FNSF The Point Solar Farm _Response to Transpower Submission (Fast Track)

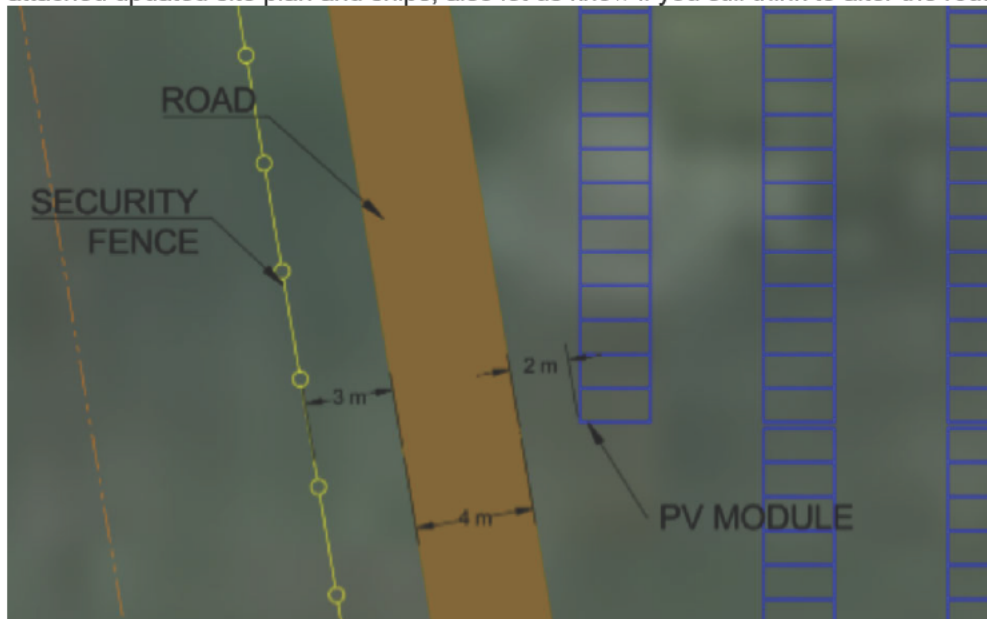
1. Plant Road / Accessways

The existing internal access road fully complies with Transpower's minimum 6m physical width requirement, comprising a 4m formed carriageway plus at least 1m clearance either side. In practice, the layout provides approximately 9m total physical width (3m setback to security fence (parallel run, non-conductive) + 4m formed road + min. 2m setback to PV modules), exceeding the minimum standard.

The access road extends through to tower BEN-ISL-A0079 from the main entrance. Please refer to the attached updated site plan and snips, also let us know if you still think to alter the route.

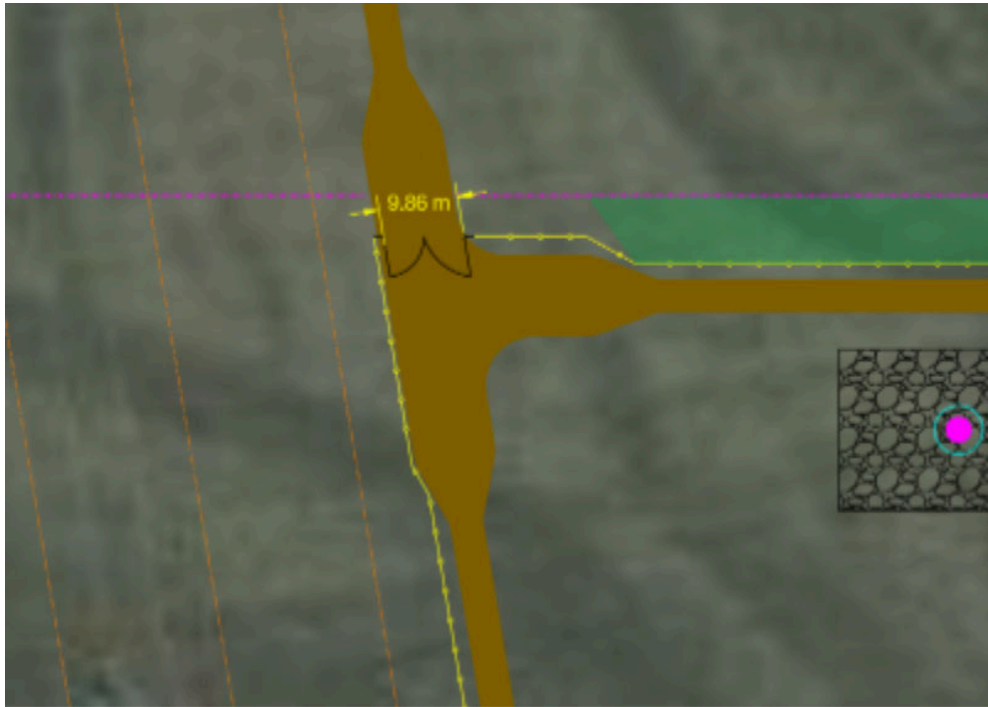
3. Fencing & Gates

The main site entrance gate is minimum 10m wide to accommodate large machinery. In addition, a 6m-wide emergency access gate is provided along the National Grid corridor.

Fencing near the transmission line will comply with NZECP34 requirements, including non-conductive materials or appropriate earthing where required. A fencing layout plan can be provided for review as part of the TCMP process.
